HOPE CREEK GENERATING STATION
FACILITY OPERATING LICENSE NO. NPF-57
DOCKET NO. 50-354

Subject: **RESPONSE TO REQUEST FOR ADDITIONAL INFORMATION,
RELIEF REQUEST HC-RR-I2-W02
PROPOSED ALTERNATIVE REPAIR METHOD**

RESPONSE TO RAI #1 FOR RELIEF REQUEST HC-RR-I2-W02

Figure 1

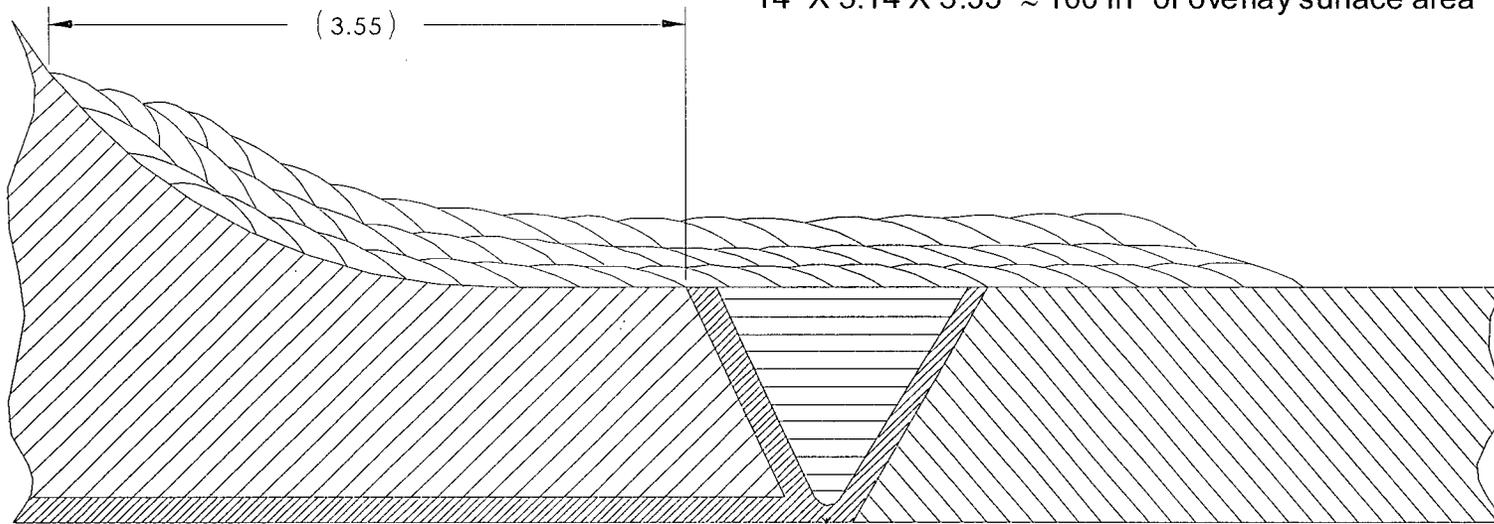
NRC RAI #1: PSEG has stated that the weld overlay of the safe end-to-nozzle weld may require welding on more than 100 square inches of surface on the low alloy steel base material. The NRC has not approved any request over 300 square inches. What is the maximum area of the P-3 material that will be welded on? This should be stated in Relief Request HC-RR-I2-W02. The Relief Request mentions 500 square inches, but not as the maximum that is to be welded on during this welding.

Total area of coverage over P3 material (using 3.55" length of overlay measured from nozzle/buttering HAZ to last bead on nozzle, see Figure 1):

Neglecting the slight curvature of 14" O.D. nozzle; 3.55" from nozzle HAZ to toe of last bead on P3 material; $14" \times 3.14 \times 3.55" \sim 160 \text{ in}^2$ of overlay surface area
